#### CITY OF KELOWNA

APPLICATION NO. DP09-0015

TO APPROVE A DEVELOPMENT PERMIT FOR THE FORM AND

CHARACTER OF THE PROPOSED 4 STOREY, 40-UNIT SUPPORTIVE

MAIN FLOOR PLAN

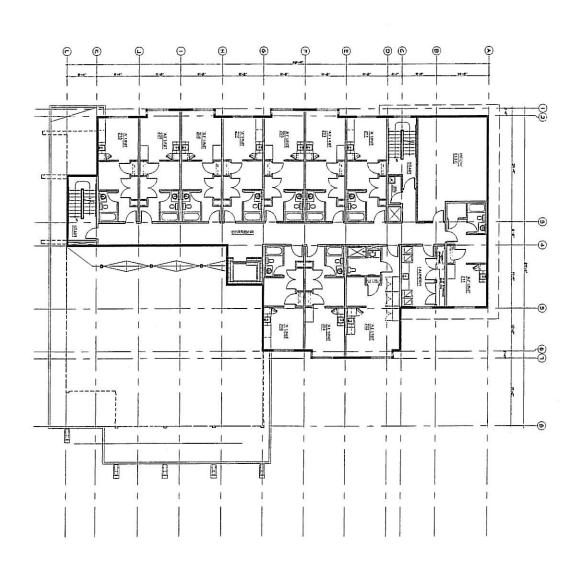
Dining/lounge on main floor requires two exits. No building code issues that effect form and character of proposed building. Building elevation to be above high water mark level of mill creek.

- There appears to be inadequate exiting in the lounge/eating area.
- Fire protection information not provided. It appears fire flows for the complex will not be met. Engineered fire flows are required to determine if existing hydrants/fire flows are adequate and if additional hydrants/fire flows are required.
- Detailed building code analysis (detail equivalencies, if any) required for proposed building at permit stage; to include exiting, fire protection information, occupancy class, building height, construction type, among other things.
